TO: Development Review Board
FROM: Ken Lerner
DATE: October 21, 2014
RE: 15-0397CA, 1127 North Avenue

Request: Construct new single story building addition to existing hardware store for retail space.

PROPOSED NORTH ELEVATION

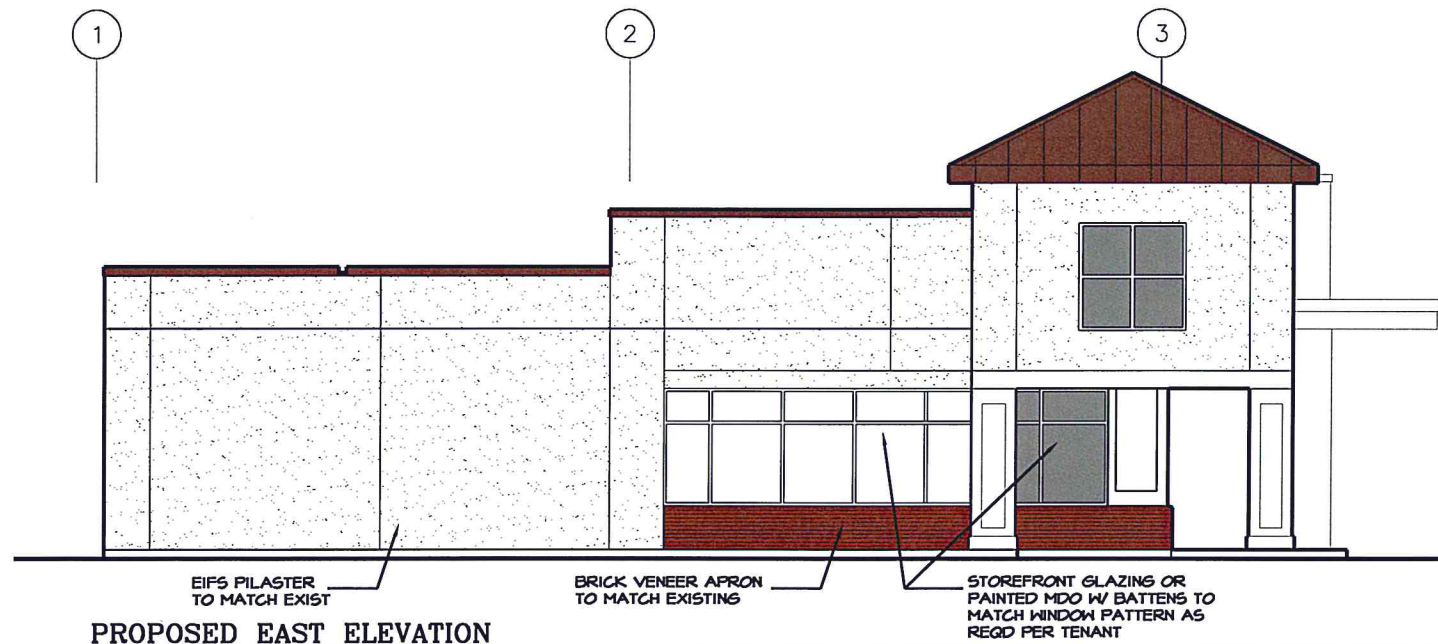
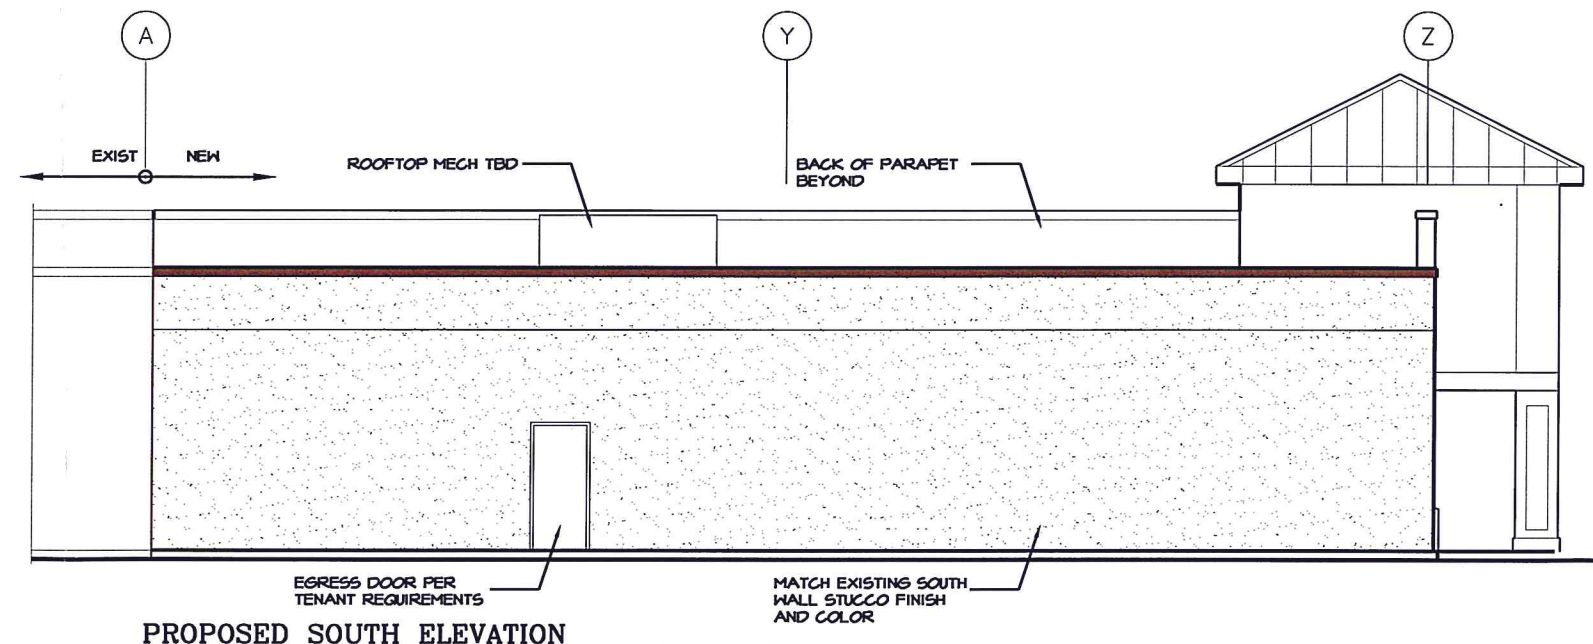
Overall building height will match the existing building at 19.5 feet high and includes a tower element at the eastern & north corner that is 27.5 feet to the peak; under the maximum permissible 35' height.

The proposed addition continues the roof line of the existing. **(Affirmative finding)**

Building opening is at the east end under the overhang of a taller element at the corner. Nearly 50% of the building front and exposed (east) side include storefront glazing typically found in the shopping center. **(Affirmative finding)**

A metal roof and stucco siding with a brick base is proposed to be consistent with the existing building and are appropriate for this commercial building. **(Affirmative finding)**
